Junkers Profly

Service Bulletin

Check of the mounting plate at the rocket tube

Issue number: TM – 001-09 – Mounting plate rocket – Revision 02

Photo 1

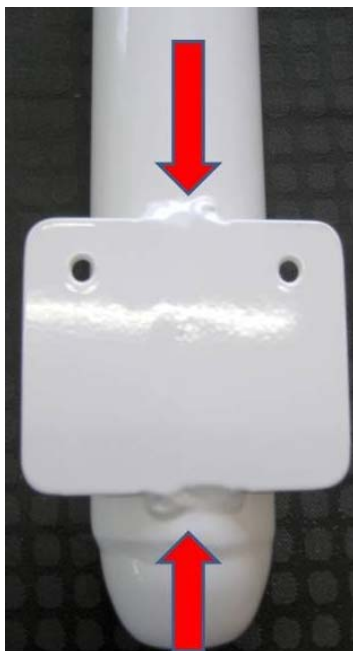
Reason: possible cracking at the welded connections between rocket tube and rocket mounting plate

Subject: visual check of the welded connections (s. photo 1)

Maintenance grade:	low
Qualification:	Technical expert
Repetition:	on the occasion of the yearly check
Communication:	if any cracks are found the complete rocket tube has to be sent to Junkers Profly GmbH.
